HISTORIC AND DESIGN REVIEW COMMISSION

April 06, 2022

HDRC CASE NO: 2021-592
ADDRESS: 703 MISSION RD
LEGAL DESCRIPTION: NCB 6917 BLK 0 LOT 18, 19, N IRR 98.13 FT OF 10, W IRR 110 FT OF 20, 21, 22, & E IRR 50 FT OF 23 & P-100
ZONING: C-3, H, RIO-5, MPOD
CITY COUNCIL DIST.: 3
DISTRICT: Mission Historic District
APPLICANT: FT Builder Services, LLc.
OWNER: NIZAR VENTURES LLC
TYPE OF WORK: Construction of a commercial structure with a fuel canopy, contributing status review
APPLICATION RECEIVED: February 04, 2022
60-DAY REVIEW: Not applicable due to City Council Emergency Orders
CASE MANAGER: Edward Hall
REQUEST:

The applicant is requesting a Certificate of Appropriateness for approval to construct a commercial structure at 703 Mission Road, located within the Mission Historic District and Mission Protection Overlay District 1. The existing structure and canopy located on the property is proposed for demolition.

Front and Rear
Elevations

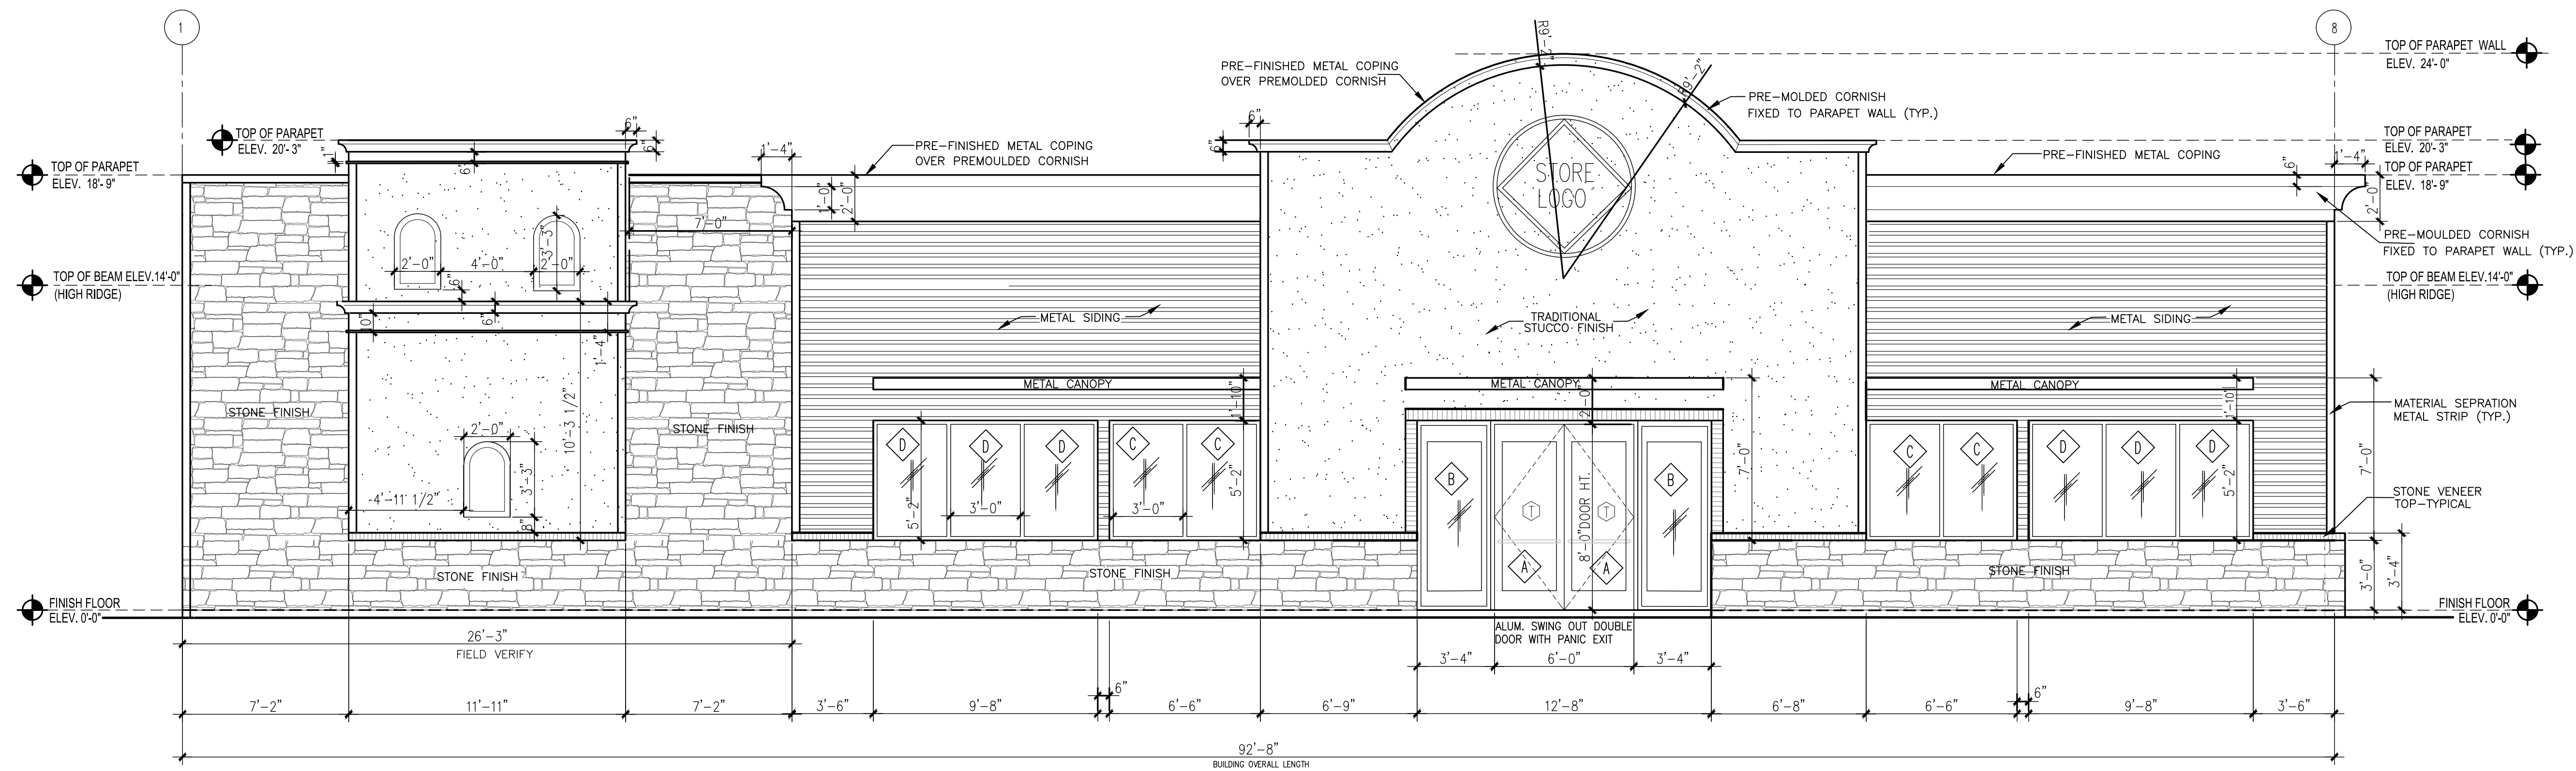
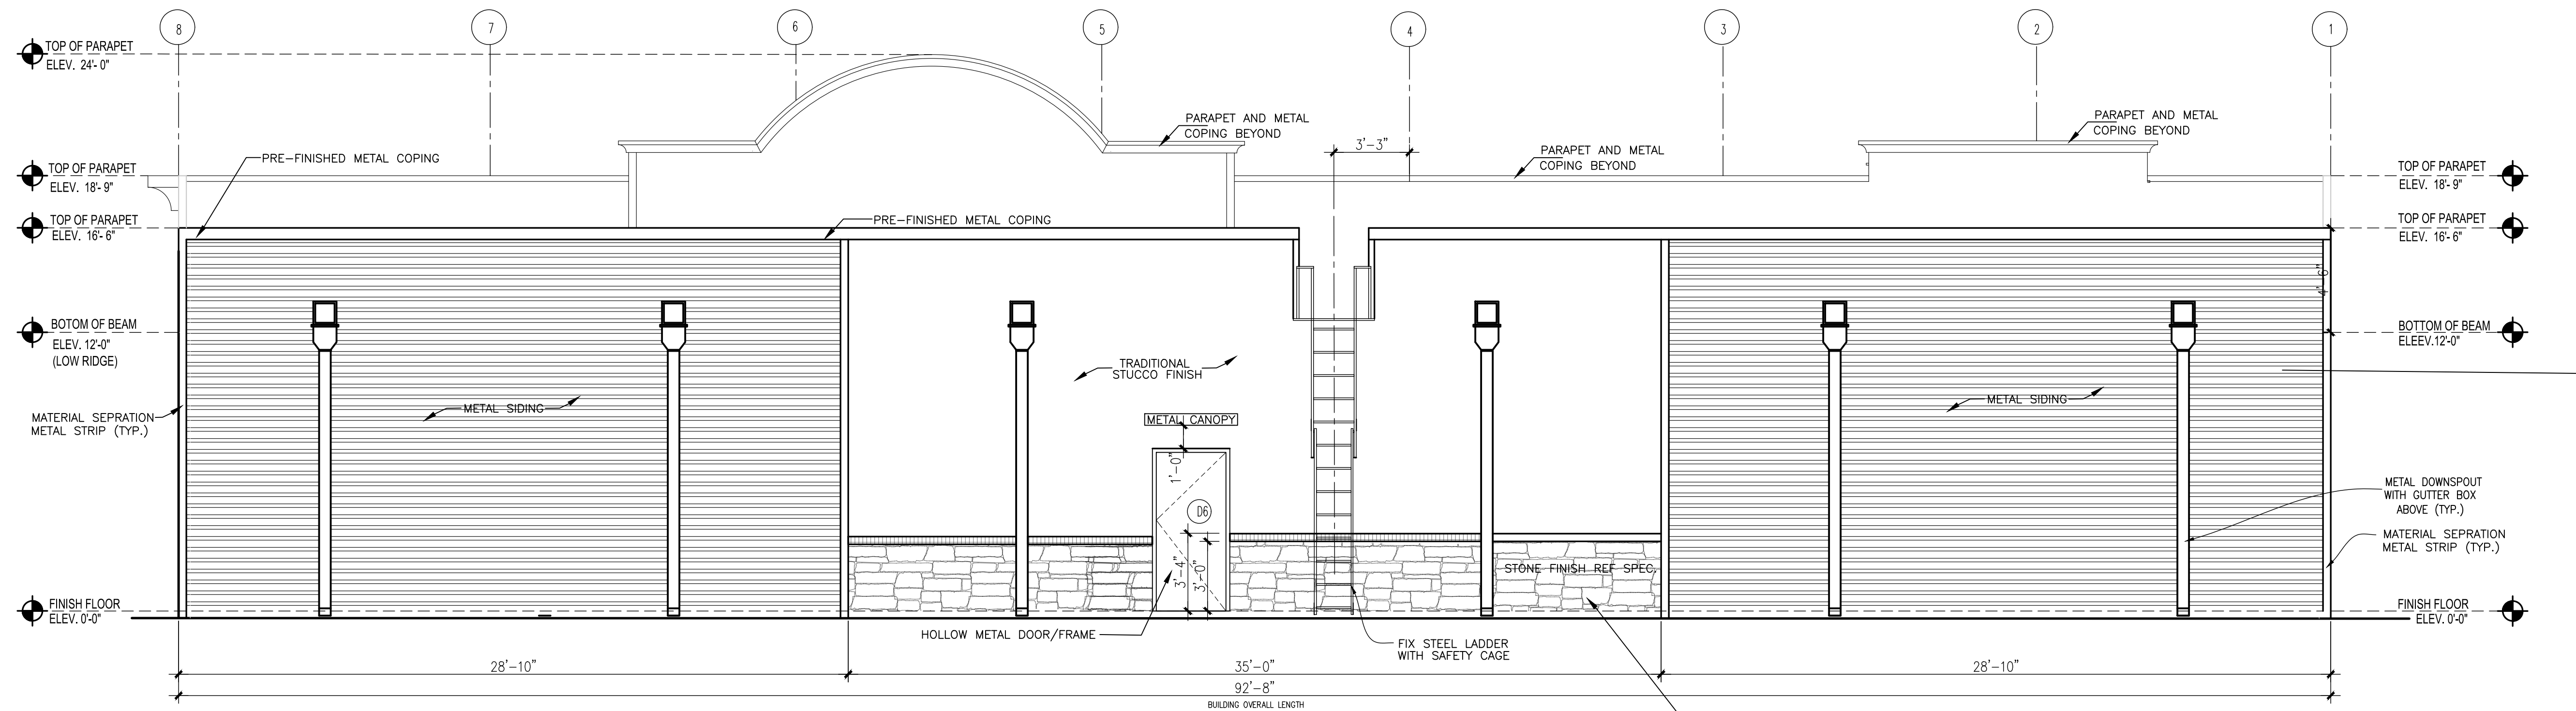
- k. NEW CONSTRUCTION (Mass, Scale, and Form) – The Mission Historic District Design Manual 2.B. notes that wall planes and fenestration should be organized to yield facades that appear monolithic and enduring while still allowing for visual interest through breaks in scale and pattern, facades should not exceed more than fifty (50) feet in length uninterrupted, and heights should not exceed more than 3 stories in height. The has proposed fenestration and a mural on three facades, and for alternating materials on the rear façade. While alternating materials separate the façade, staff finds that additional architectural elements, such as fenestration should be added to the rear façade.

- iii. That the applicant provides a designed dumpster location on site for review and approval, as noted in finding t.
- iv. That the applicant introduces elements that separate blank facades, such as changes in materials, wall planes or fenestration, as noted in finding k.
